Product Safety Recall

N202324251 Roof Rail Air Bag Inflator May Rupture

Release Date: June 2022

Revision: 03

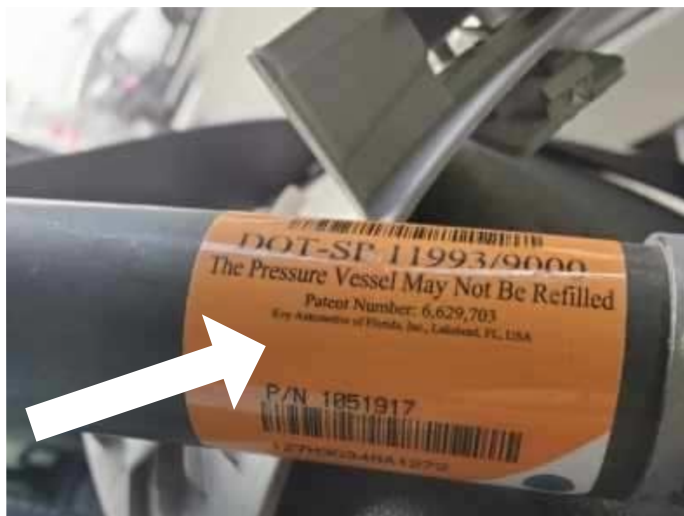
Record the serial number on each of the white airbag labels.

Do Not record the serial number (orange label) on the inflator.

Please center ONLY the QR Code within the Red Brackets as seen below. If the scan function is inaccurate, please use the guide below for entering the information manually into the RPT fields.

From the recall example photo above:

Part Number: 7503881C91

VPPS: 4770101000000R

DUNS: 74040

Traceability Number: 21221258RH006120

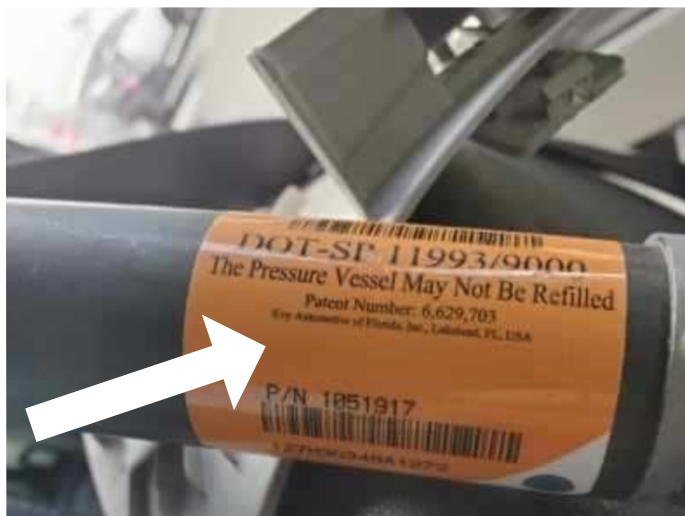
Record the serial number on each of the white airbag labels.

DO NOT record the serial number (orange label) on the inflator.
